ADDENDUM NO. 1

POLYTECH HIGH SCHOOL
RENOVATIONS AND ADDITIONS
BID PACKAGE 'A'

This addendum is hereby made part of the Project Manual and Drawings dated 9 July 2012.

CSK002

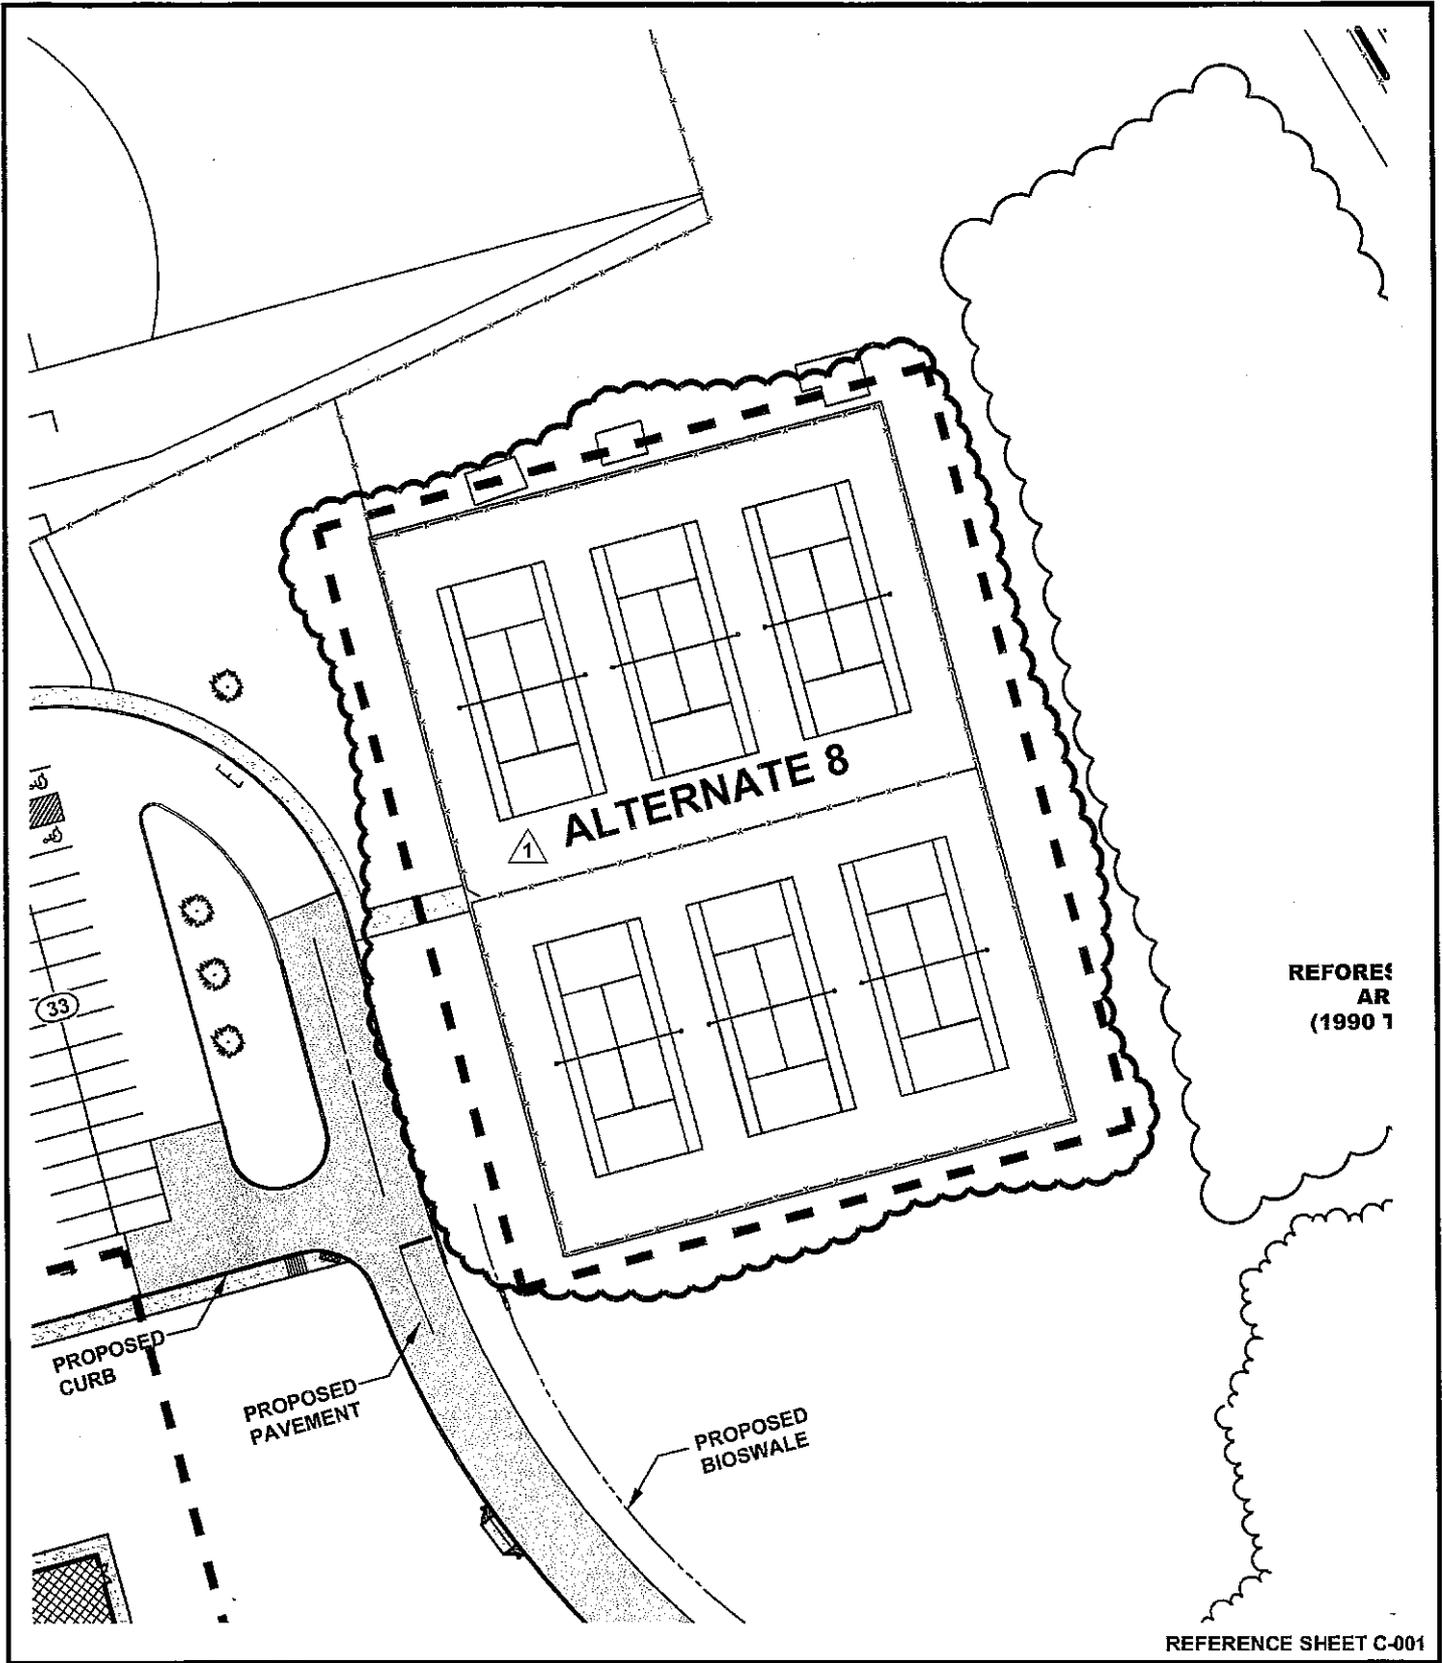
- A. **C-001 Preliminary Overall Site Plan Floor Plans** - Drawing revised as indicated on sketches CSK001, CSK002, and CSK003 and included with this addendum.

CSK006

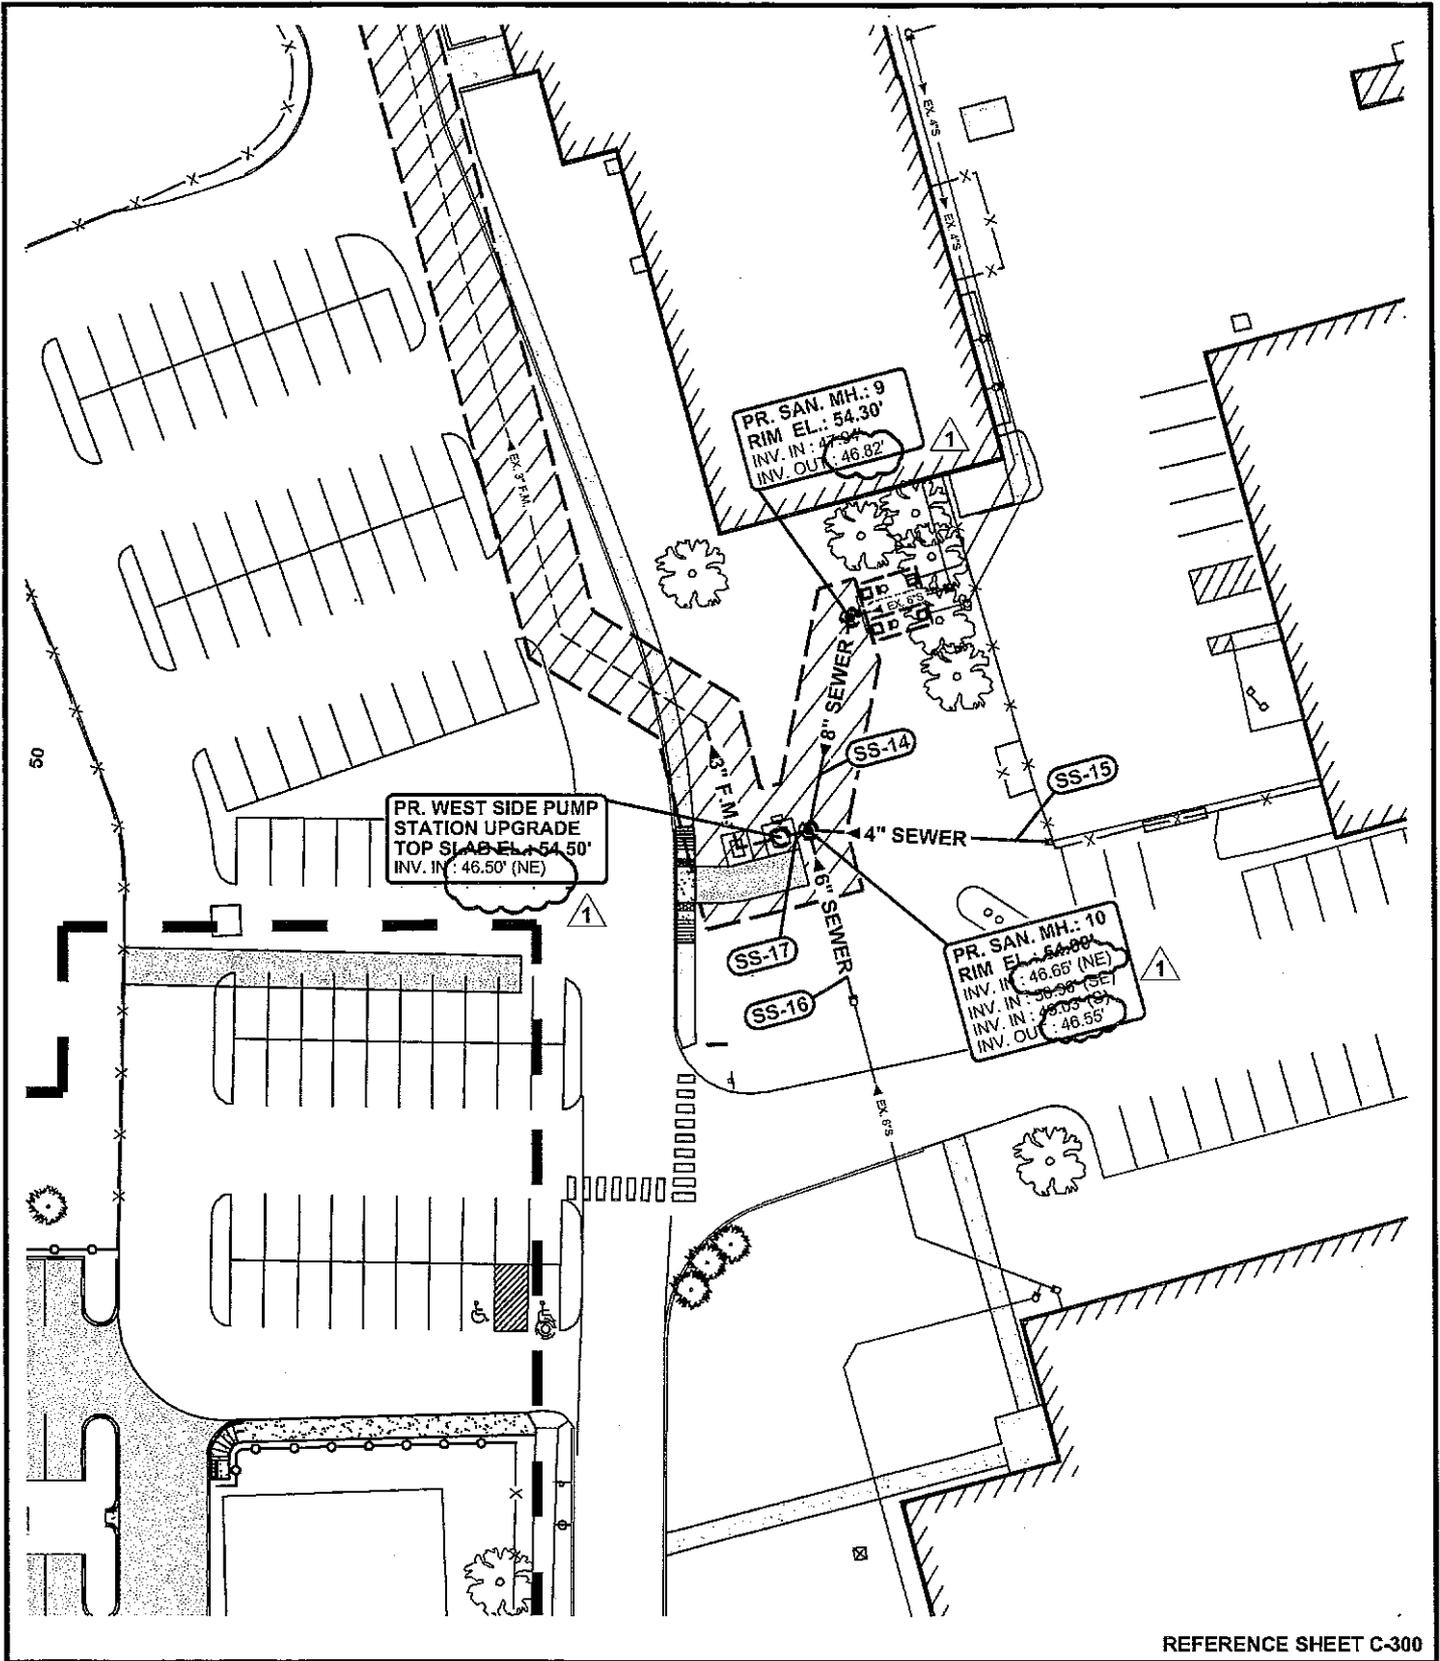
- F. **C-300 Overall Sanitary Sewer Plan** - Drawing revised as indicated on sketches CSK006 and CSK007 and included with this addendum.
- G. **C-301 Utility Plan** - Drawing revised as indicated on sketches CSK008 and CSK009 and included with this addendum.

CSK011

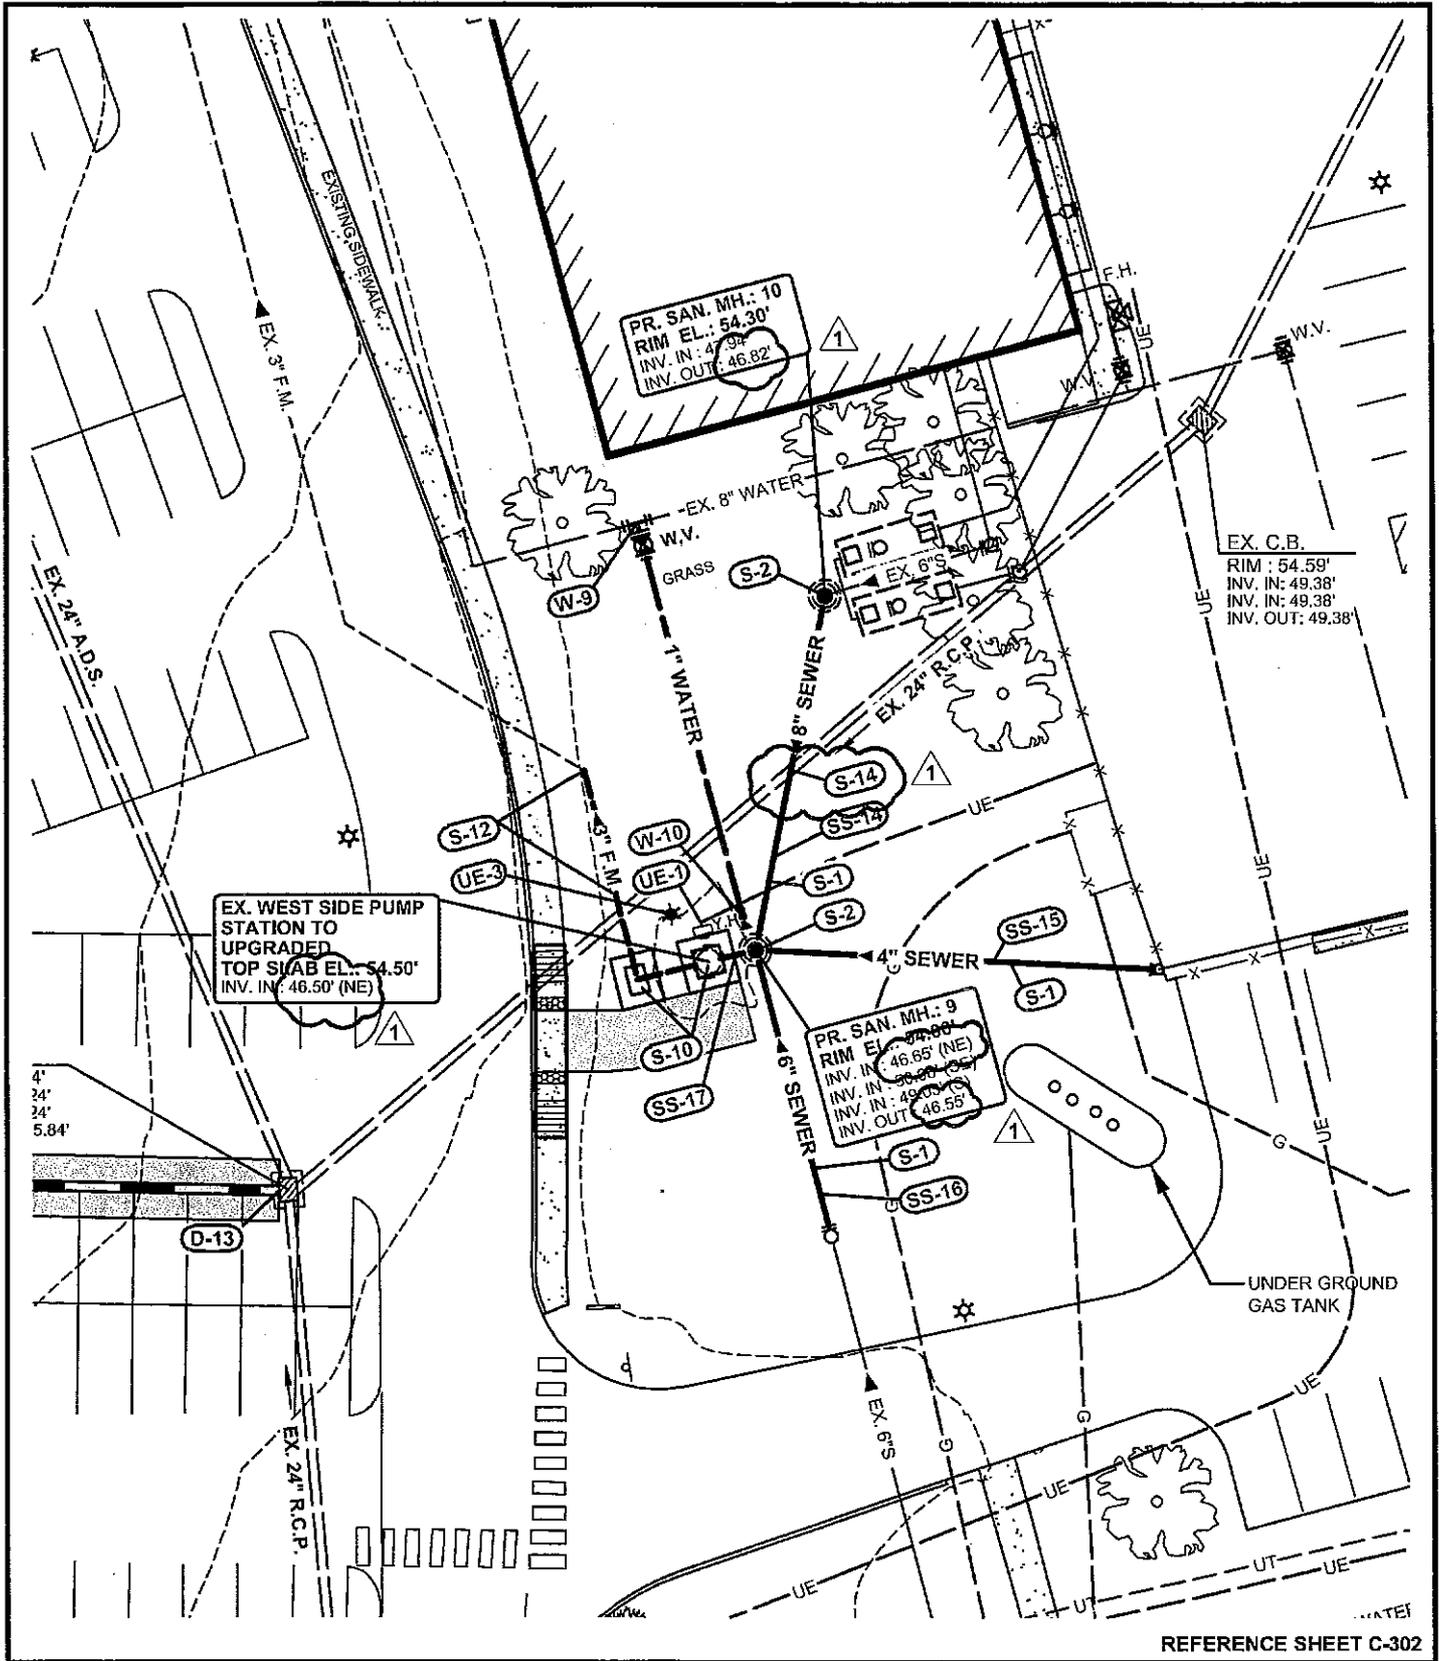
- H. **C-302 Utility Plan** - Drawing revised as indicated on sketches CSK010, CSK011, and CSK012 and included with this addendum.
- I. **C-303 West Side Pump Station Plans, Sections and Notes** - Drawing revised as indicated on sketch CSK031 and included with this addendum.

CSK014

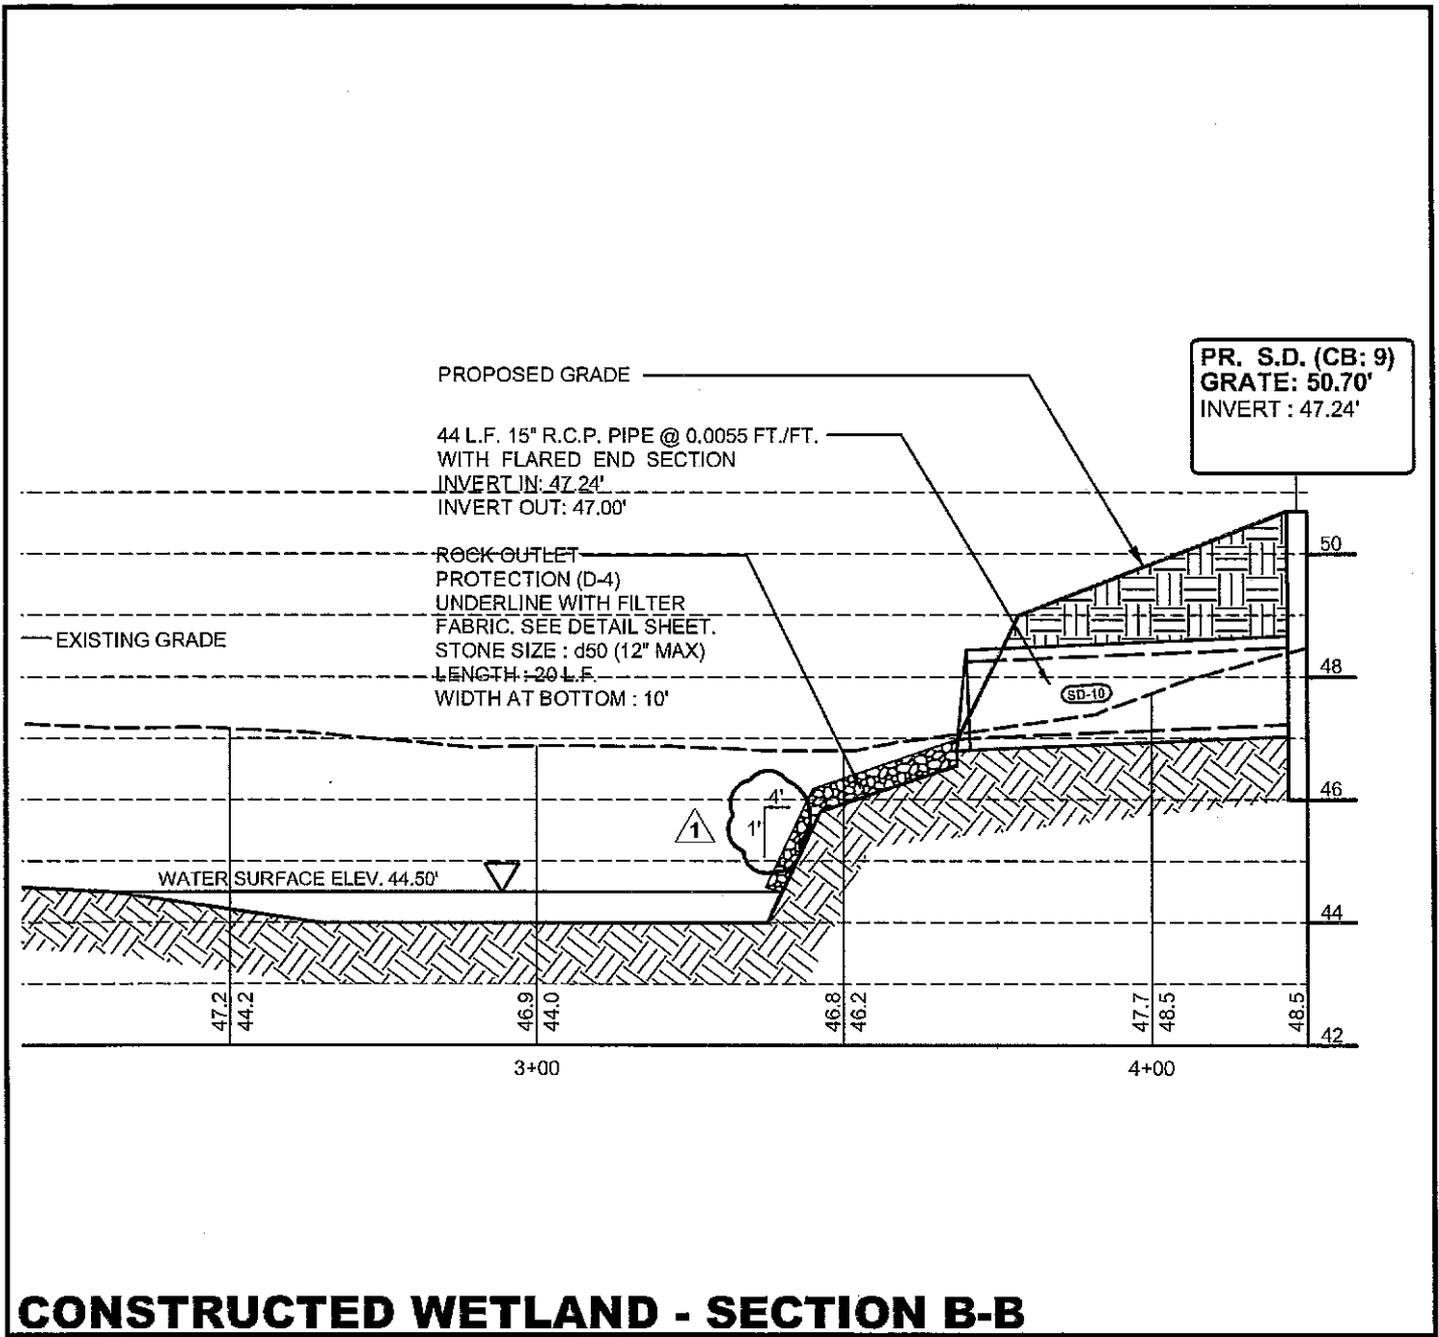
- K. **C-501 Sediment and Stormwater Management Plan** - Drawing revised as indicated on sketch CSK013 and included with this addendum.
- L. **C-504 Sediment and Stormwater Management – Bioswale 1, 2 and 3 Plan, Profile & Section and Constructed Wetland Section** - Drawing revised as indicated on sketches CSK014 and CSK015 and included with this addendum.
